AMENDMENTS TO THE DRAWINGS

In response to the Office action identified above, Fig. 2-5 has been revised. One clean copy of Fig. 2-5 has been provided along with one marked copy showing the changes made.

Fig. 2

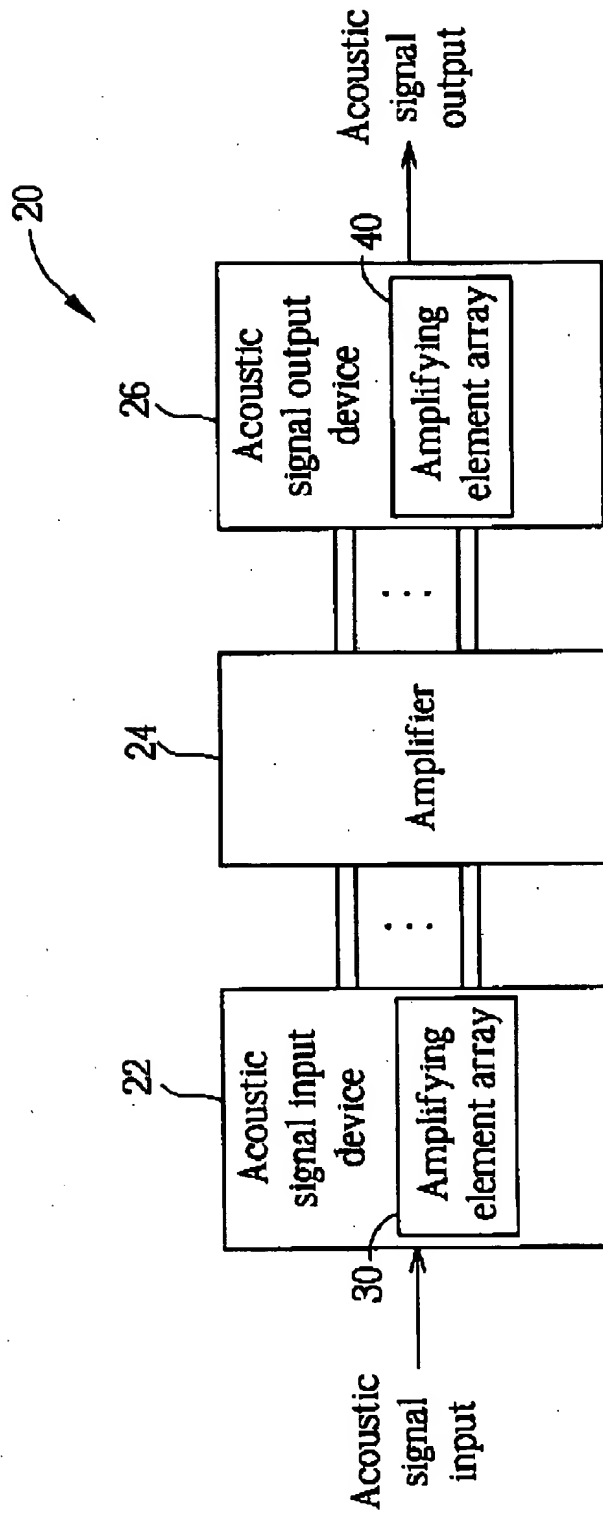
In Fig. 2, the acoustic signal input device (22) comprises an amplifying element array (30), and the acoustic signal output device (26) comprises another amplifying element array (40). The hearing aid device receives an acoustic signal input and outputs an acoustic signal output.

Fig. 3

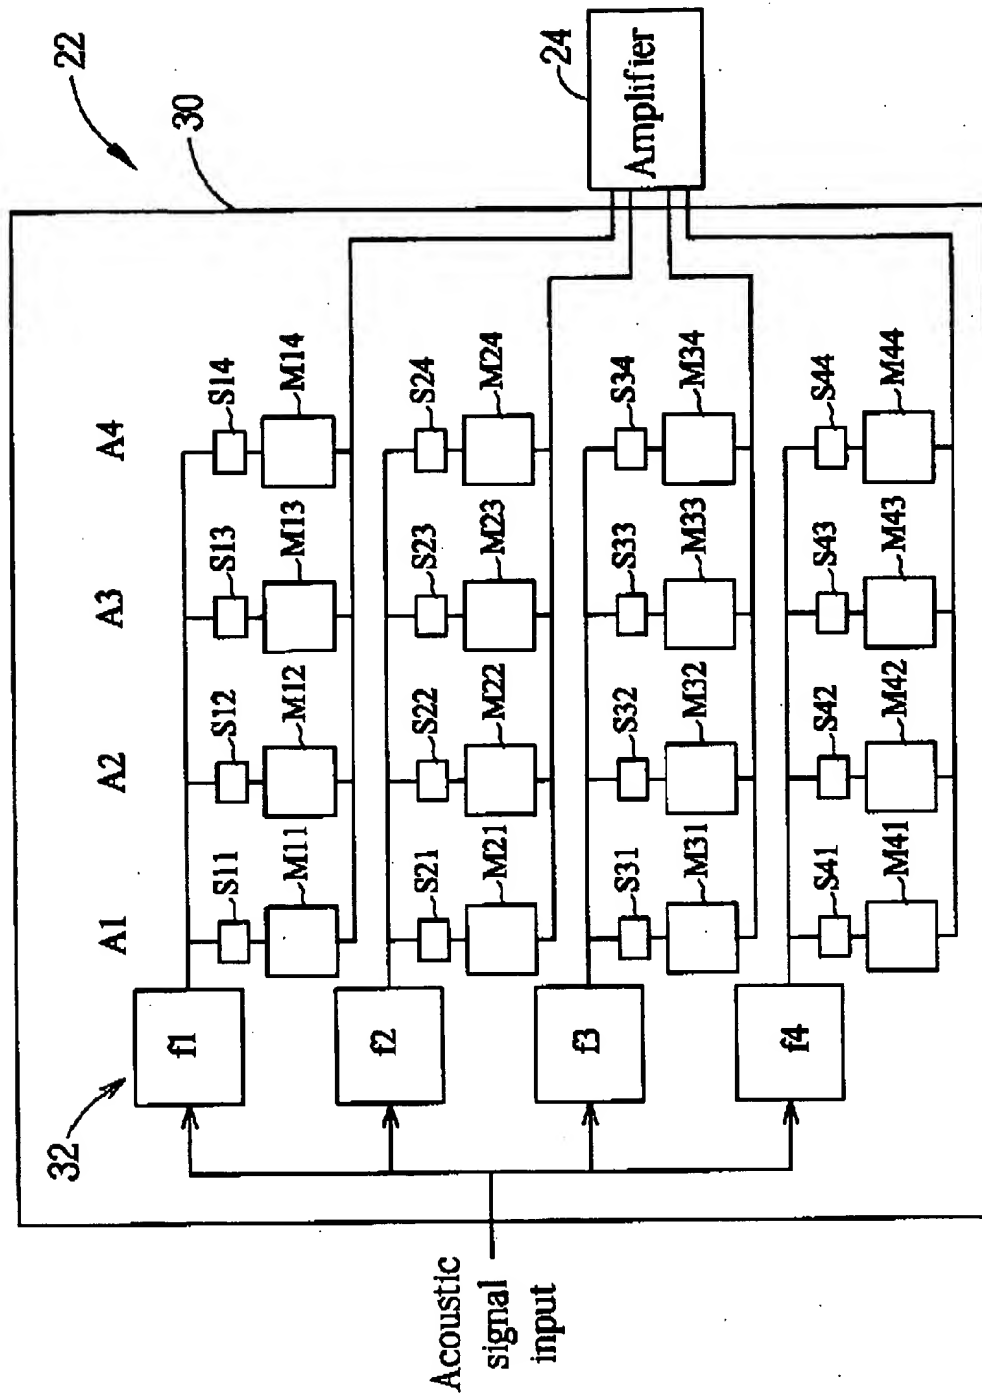
In Fig. 3, the acoustic signal input device (22) receives an acoustic signal input and comprises an amplifying element array (30).

Fig. 4

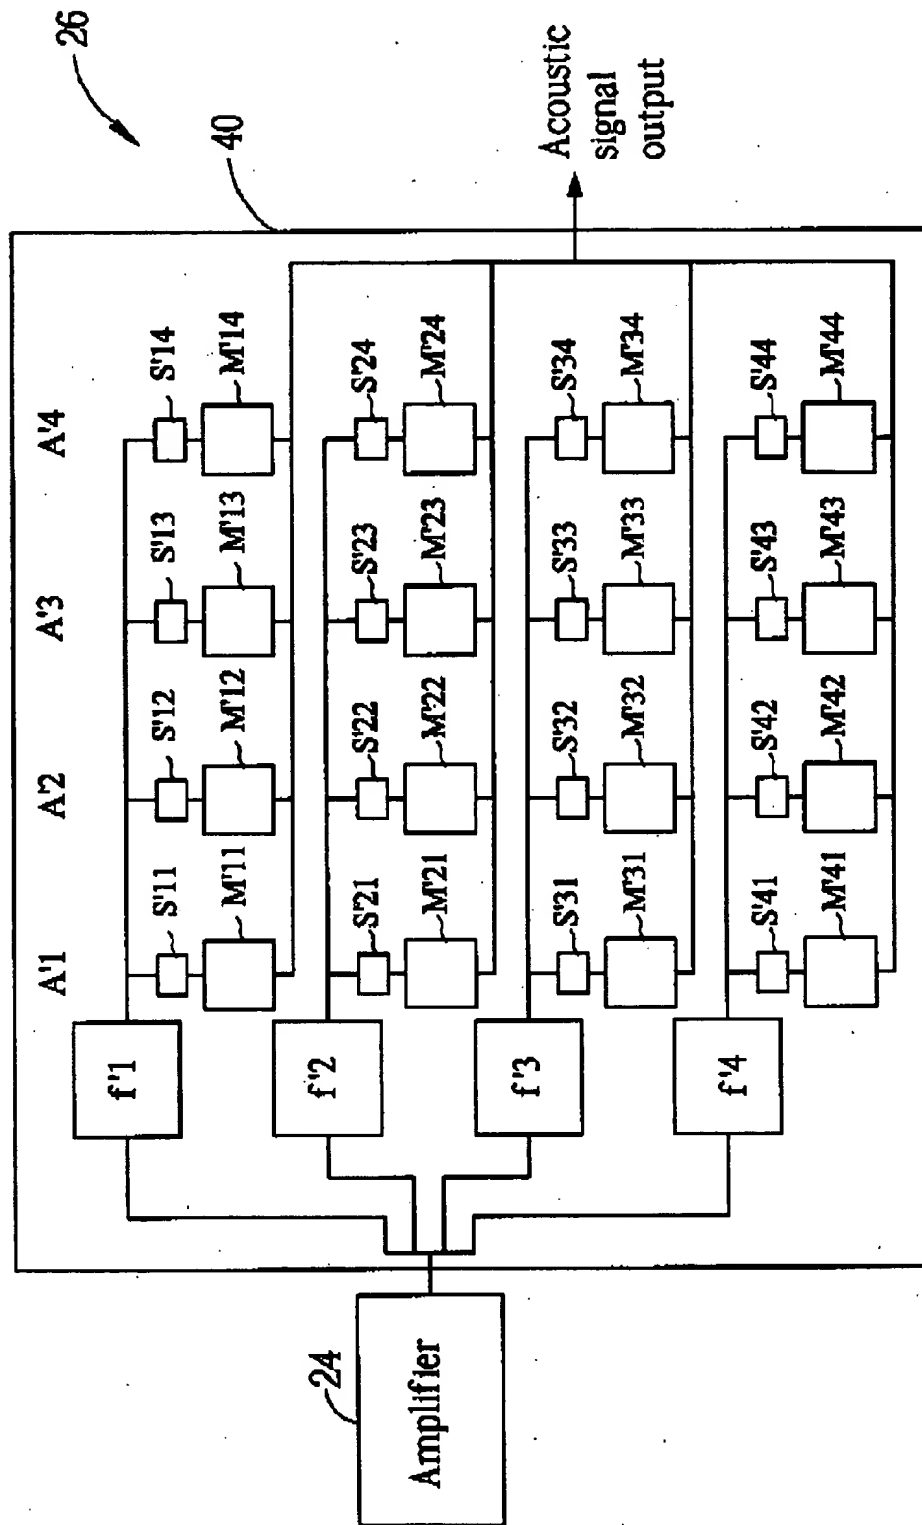
In Fig. 4, the acoustic signal output device (26) comprises an amplifying element array (40) and outputs an acoustic signal output.
